<b>Examiner-Initiated Interview Summary</b>	<b>Application No.</b>	<b>Applicant(s)</b>	
	10/737,039	LEE ET AL.	
	<b>Examiner</b>	<b>Art Unit</b>	
	Robert J. Sandy	3677

SUBSTANCE OF INTERVIEW DESCRIBING THE GENERAL NATURE OF WHAT WAS DISCUSSED:

*FIG. 4*  
*Prior Art*

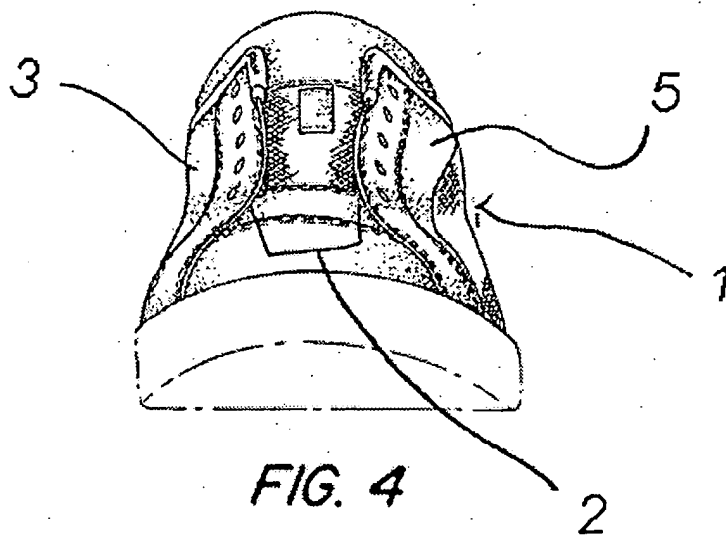
Continuation of Substance of Interview including description of the general nature of what was discussed: Claim 1 was proposed to be canceled in favor of claim 6 provided in the Examiner's Amendment, which further clarifies the claimed invention. Claims 2 through 5 were suggested to be canceled. Replacement/substitute drawing sheets incorporating corrections were proposed to remove the drawing objections indicated in the prior Office action. An Examiner's amendment will be written to include the proposed allowable claim 6 and approved formal drawing sheets.

Approved DR 11/11  
 Offspring DR 11/11
